**CLOSEOUT REPORT
FOR THE FORMERLY UTILIZED SITES
REMEDIAL ACTION PROGRAM
(FUSRAP) – MADISON SITE**

Madison, Illinois

**POST-REMEDIATION ACTION REPORT
FOR THE MADISON FUSRAP SITE
MADISON, ILLINOIS**

**Errata Sheet for the
Post Remedial Action Report for the Madison FUSRAP Site
Madison, Illinois
September 2000**

Figure 3. Class 1 and Class 2 Survey Unit Measurements at the 25 Foot Level

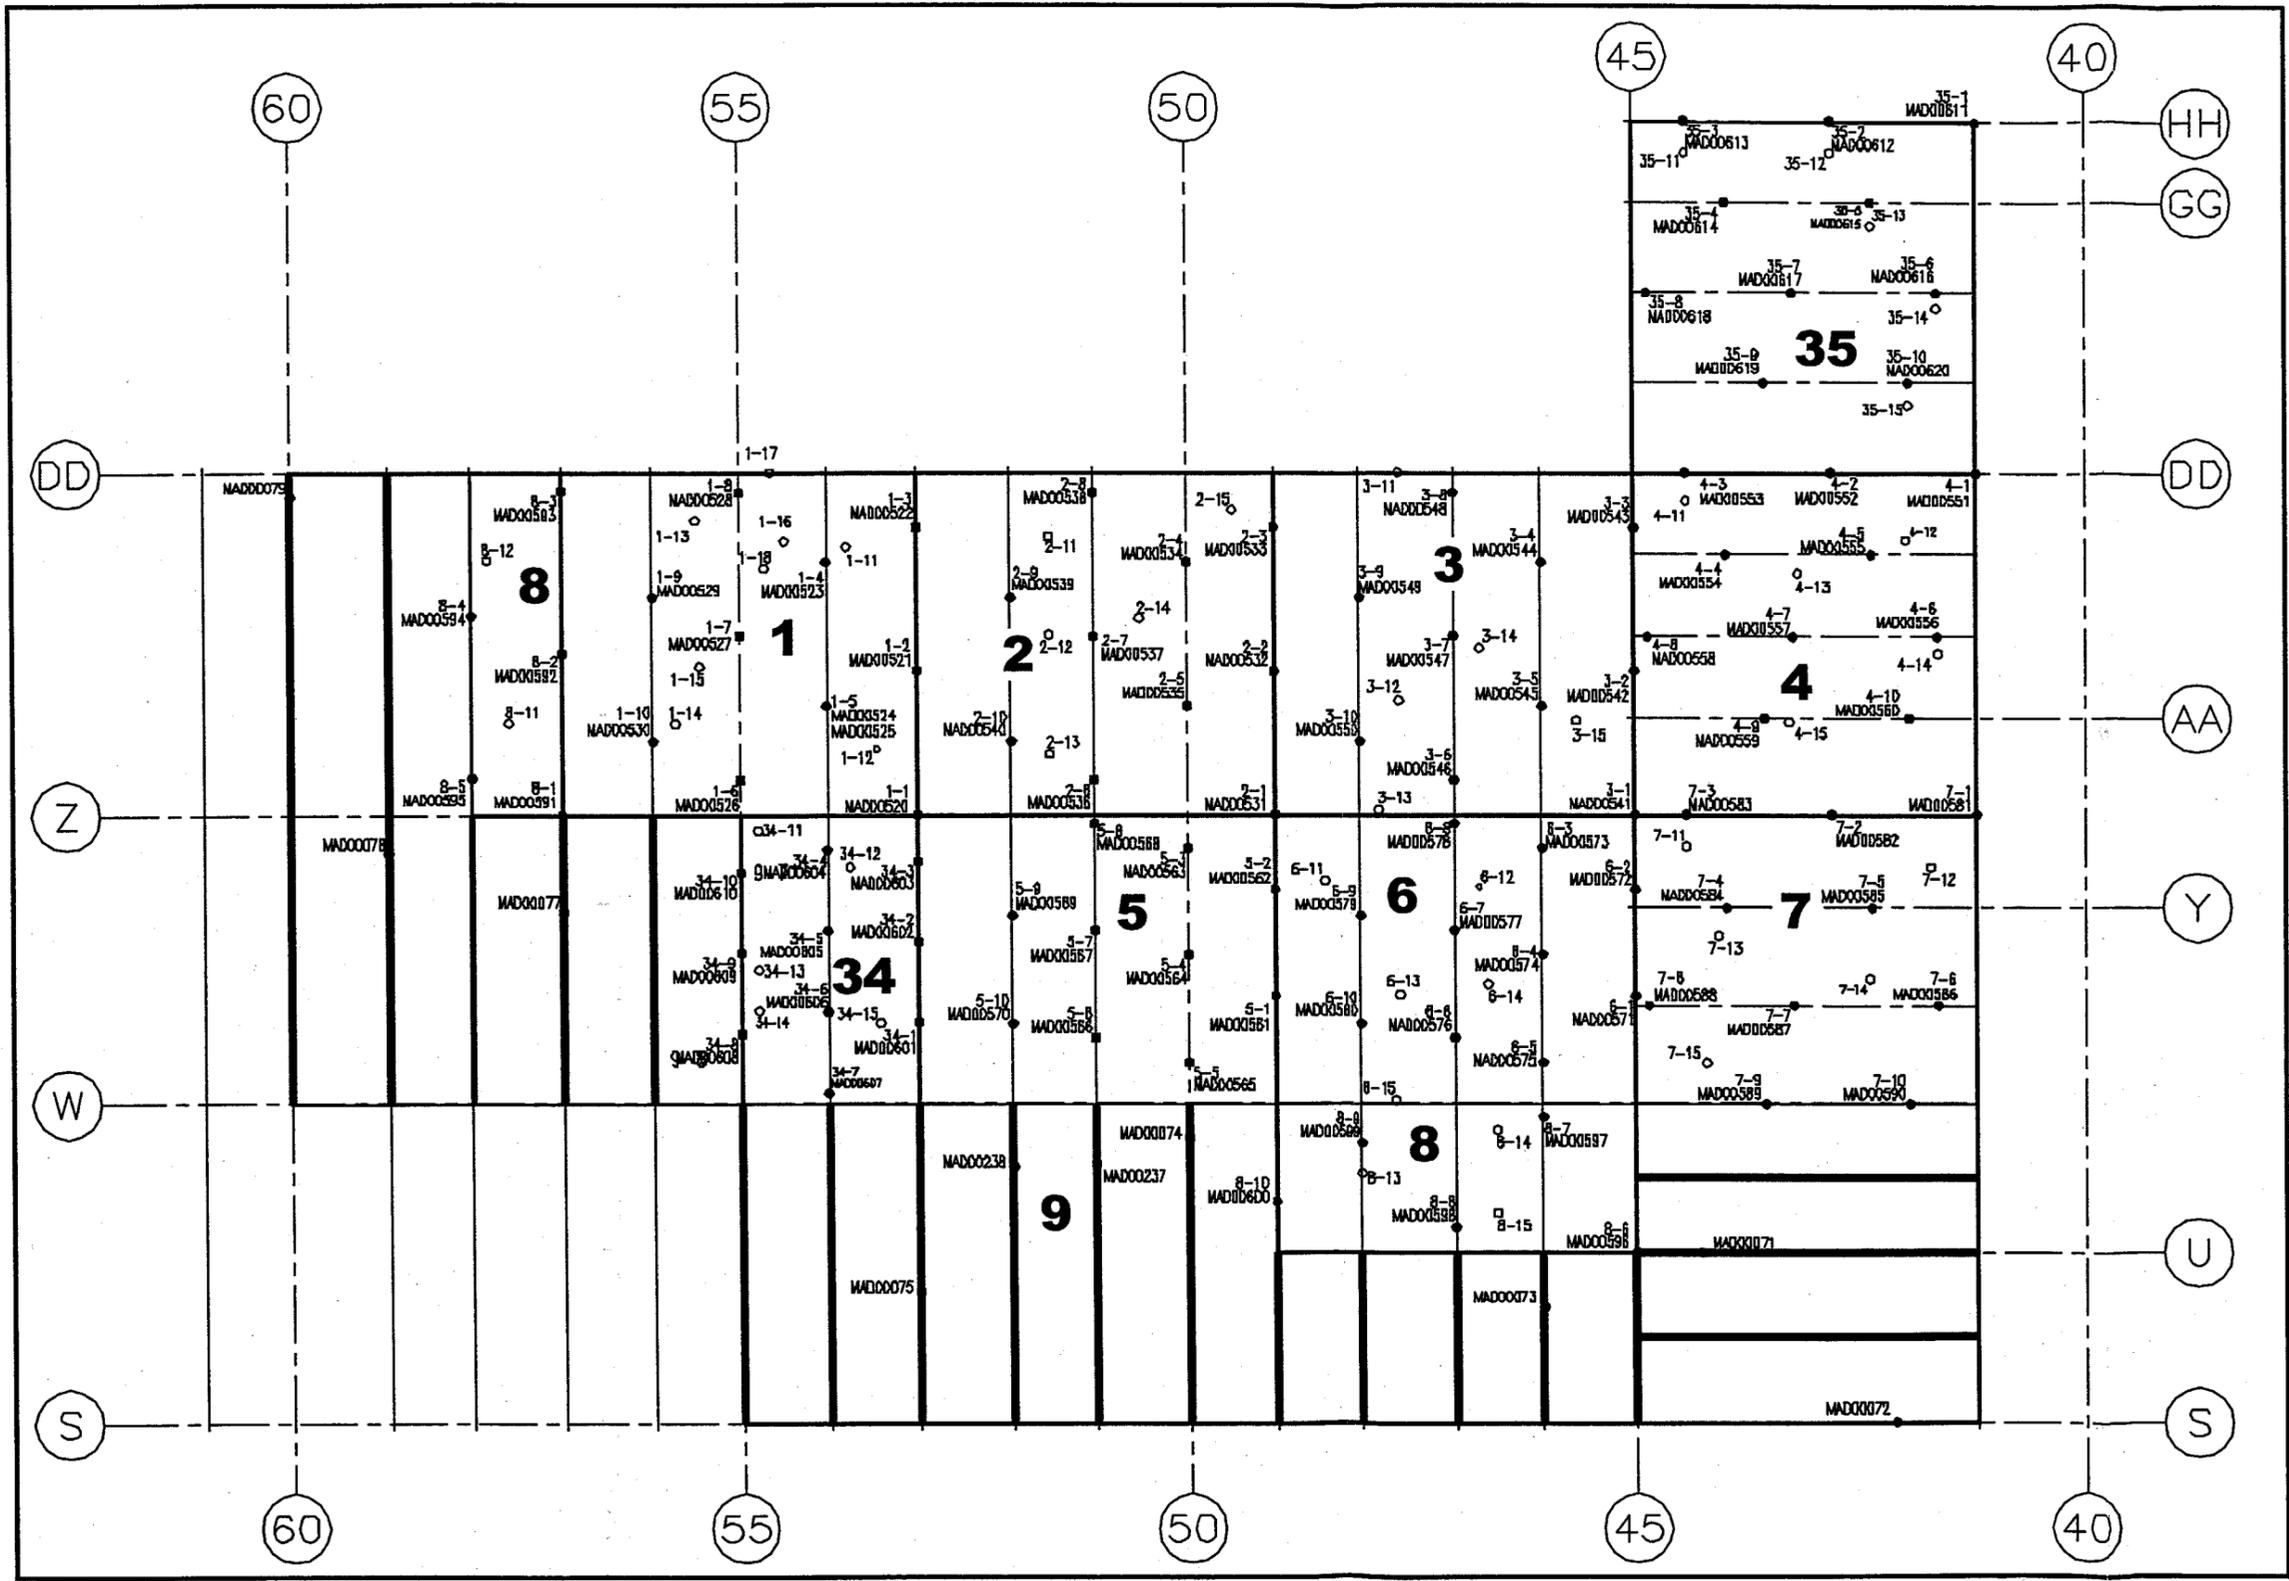
4. Figure 3, Legend. Add an unfilled circle to the legend with the text “The unfilled circles represent biased samples collected on cross member structure surfaces other than truss beam surfaces.”

Figure 4. Class 1 and Class 2 Survey Unit Measurements at the 36 Foot Level

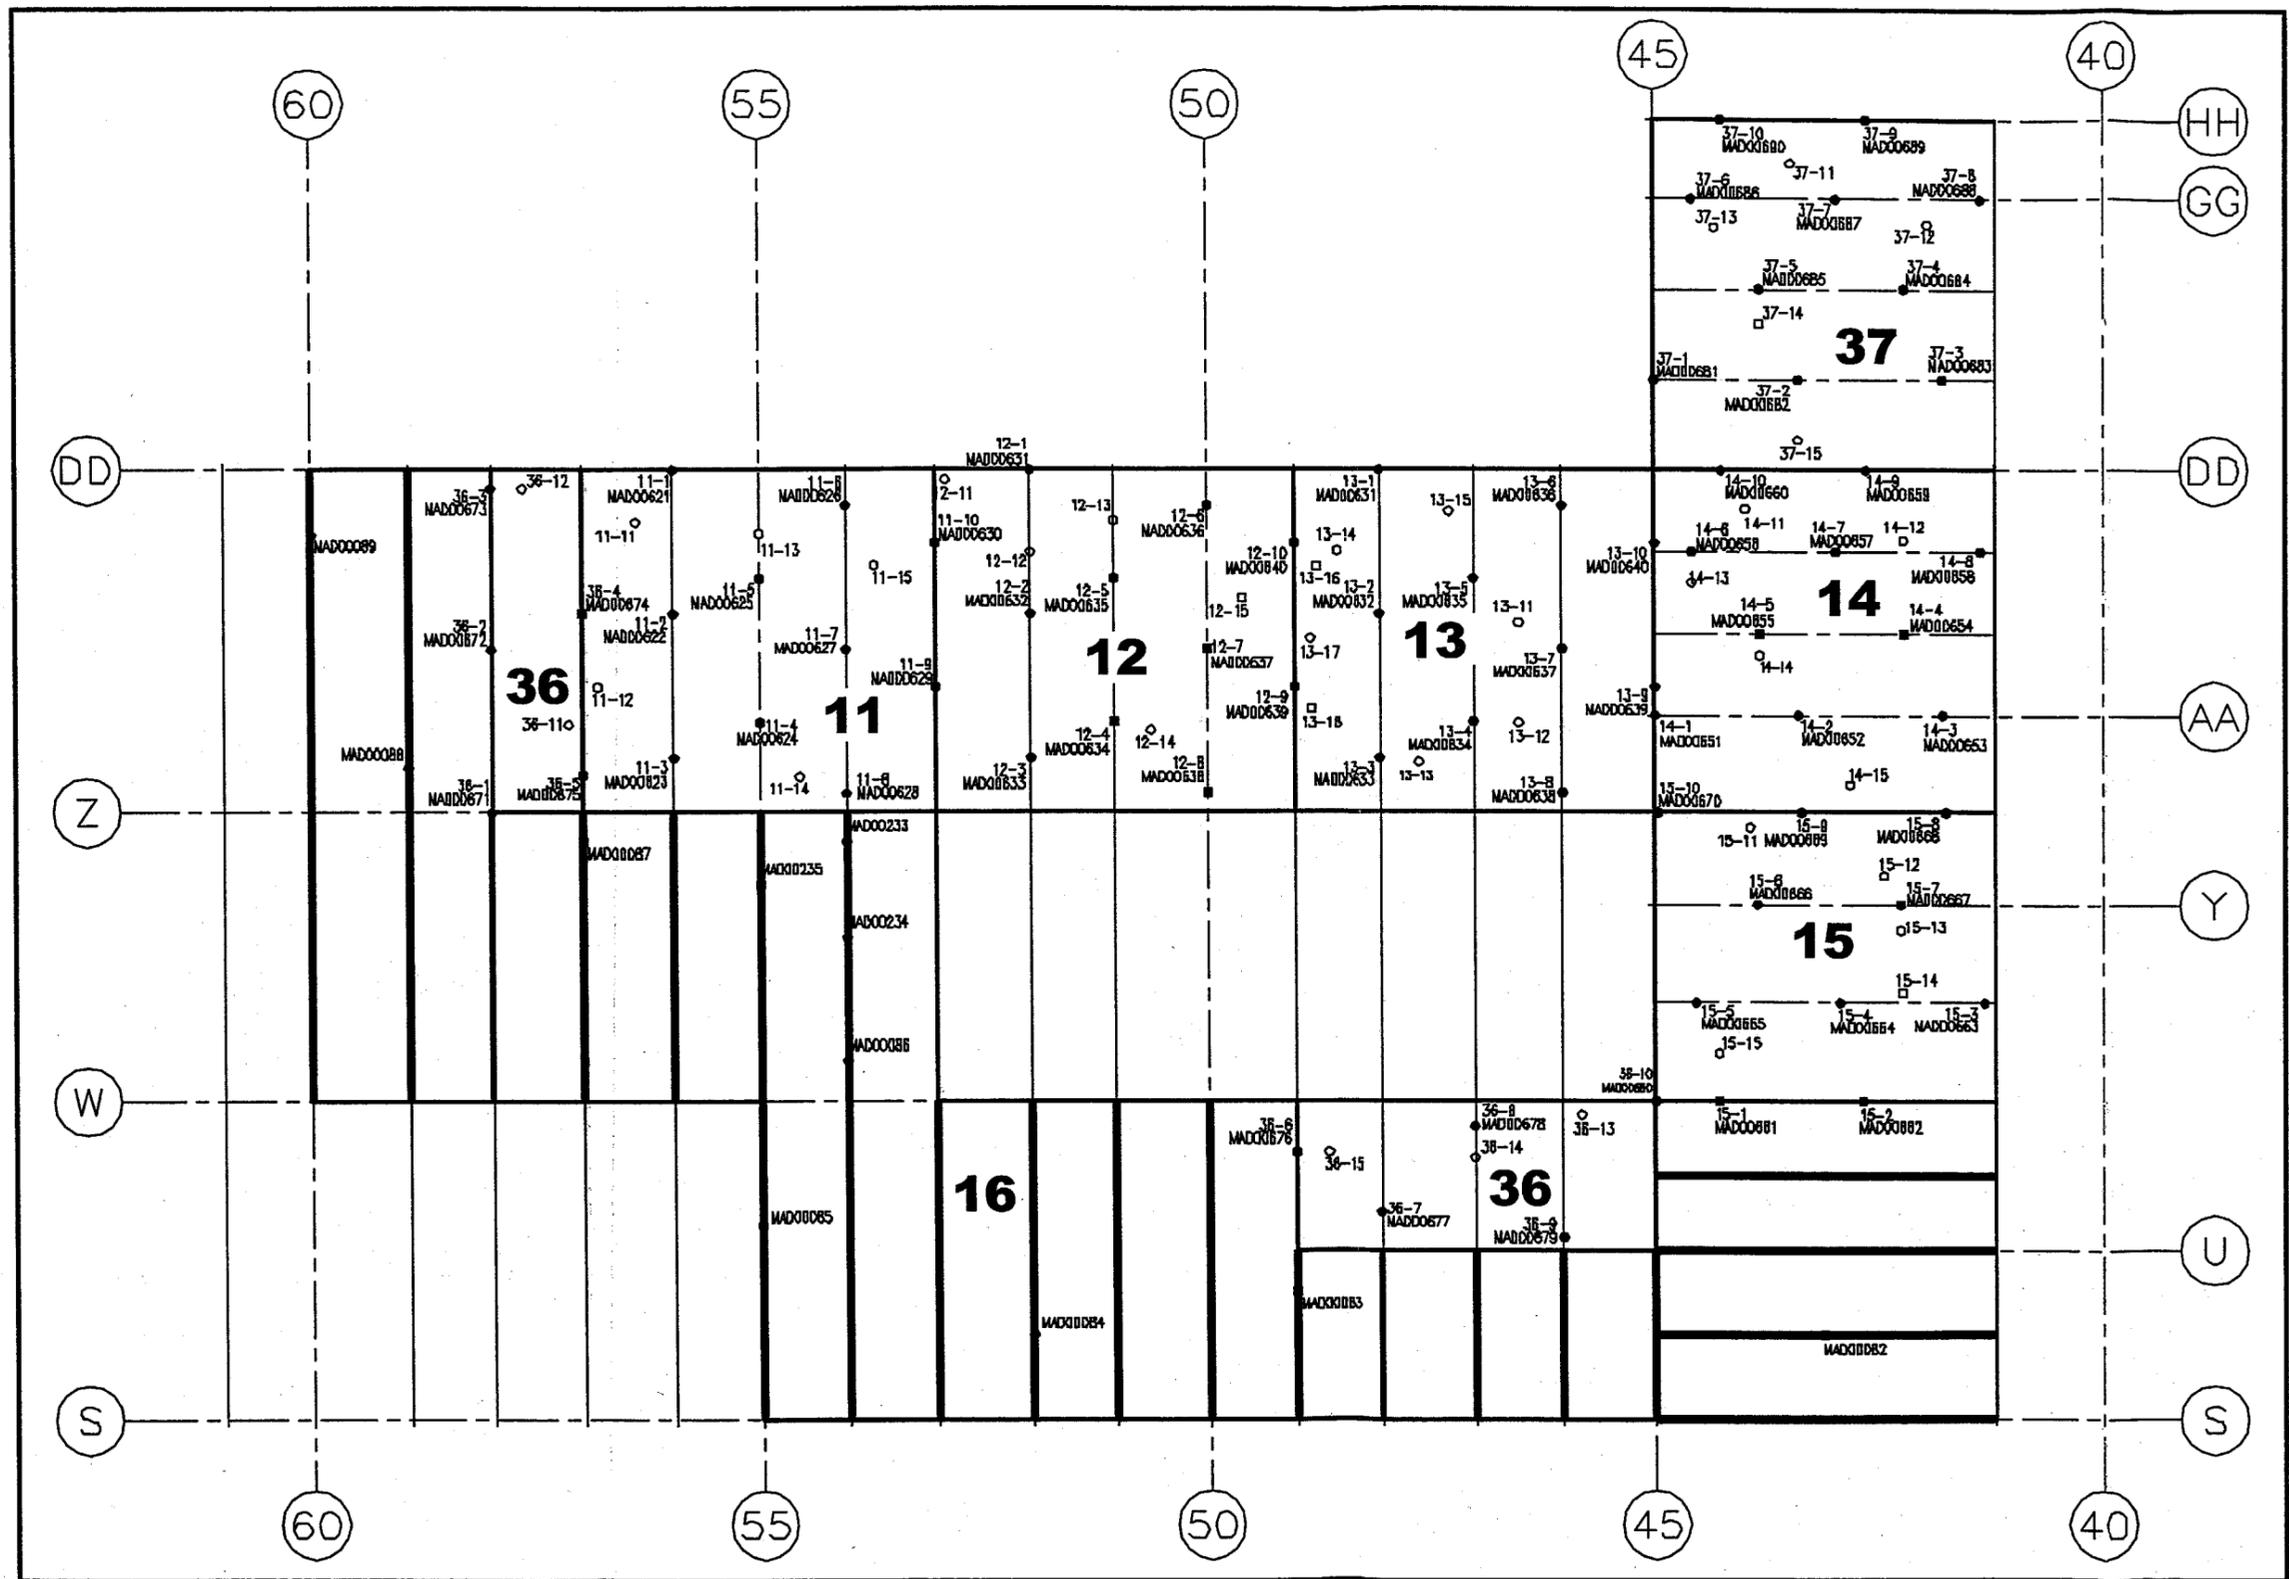
5. Figure 4, Legend. Add an unfilled circle to the legend with the text “The unfilled circles represent biased samples collected on cross member structure surfaces other than truss beam surfaces.”

Figure 9. Class 3 Floor Survey Unit Measurements

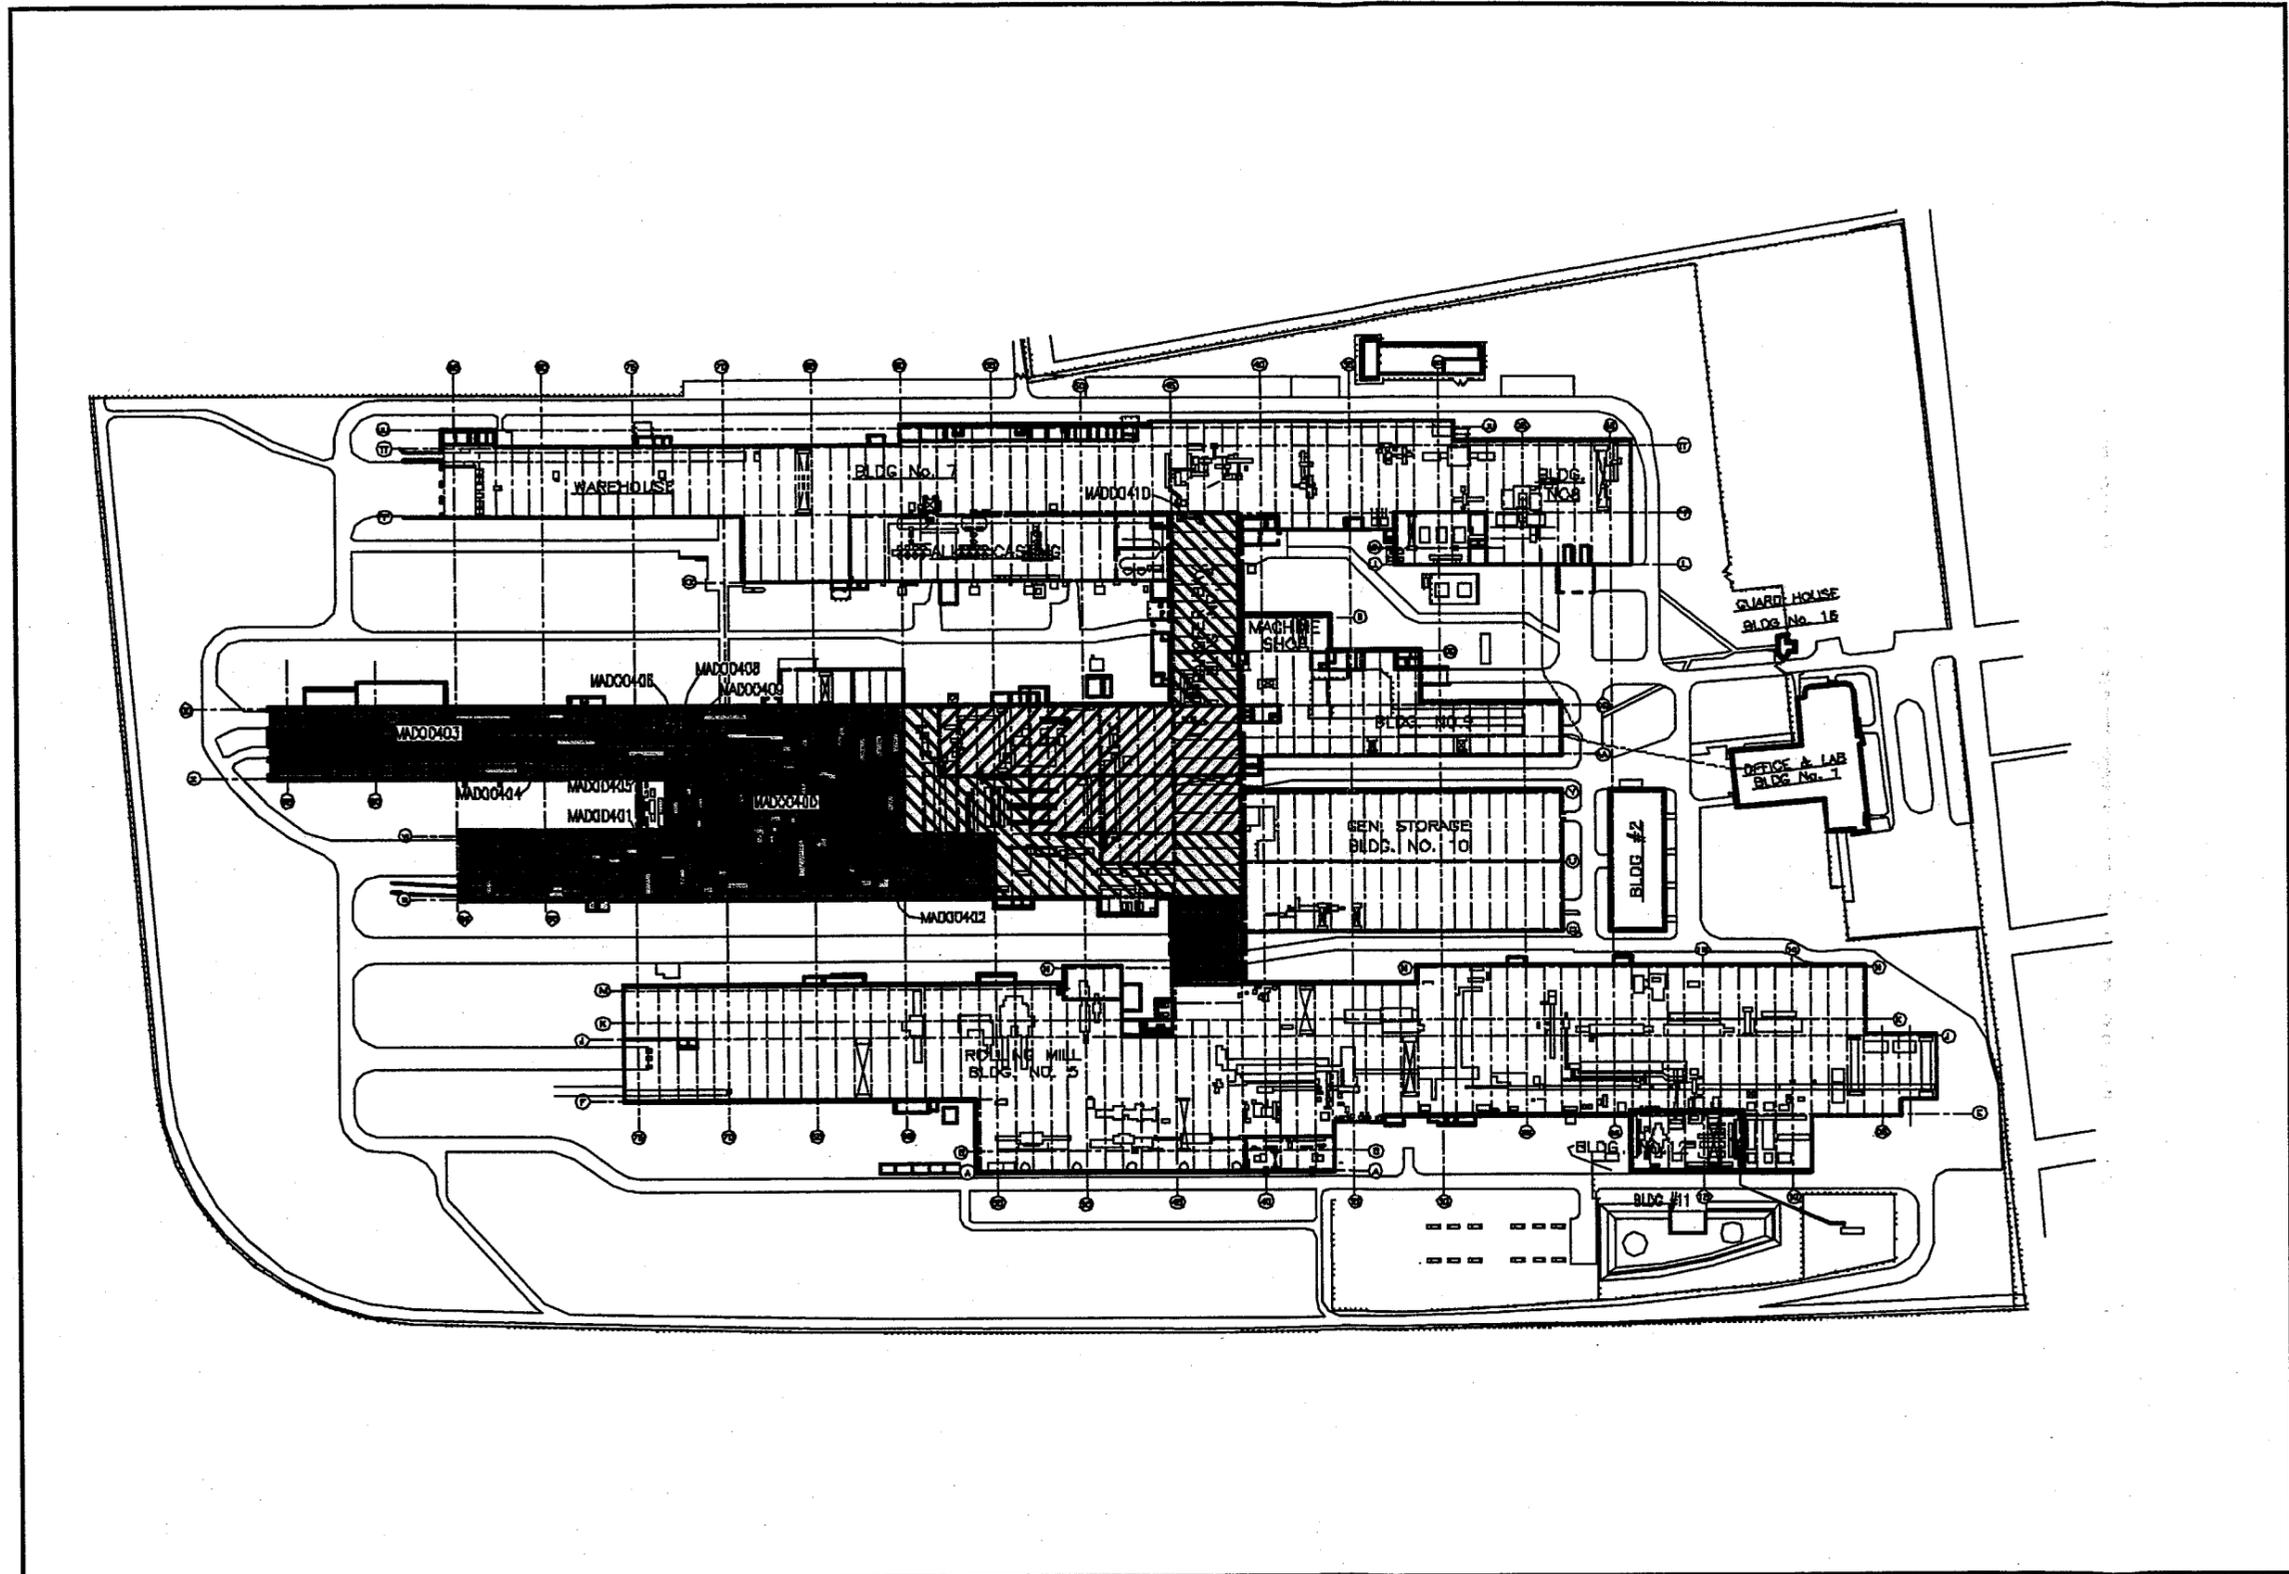
6. Figure 9, Legend. Add note to state: “The orange dots represent samples collected on cross members. Note that they do not have sample numbers because there were no measurements that exceeded even a small fraction of the DCGL in this survey unit.”
